Access Compliance Report

Public Rights-of-Way

(Curb Ramps)

Intersection ID: 13985	Main Street: CAMDEN_RD	Cross Street: EAST_BV	Location: SW
ADA ID: 8D6777AFF1B7	Ramp Type: Directional1	Initial Pass/Fail: Fail	Overall Compliance: No
Codes/Mitigation Info/Possible Solution		Field Measurements/Component Compliance	
Severity Score: 13.75

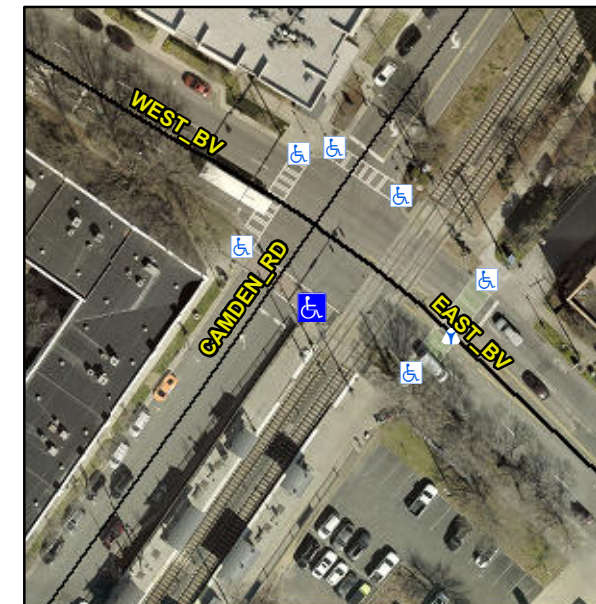
XWALK PAVERS

R304.2.2

Remove & Replace Entire Ramp.
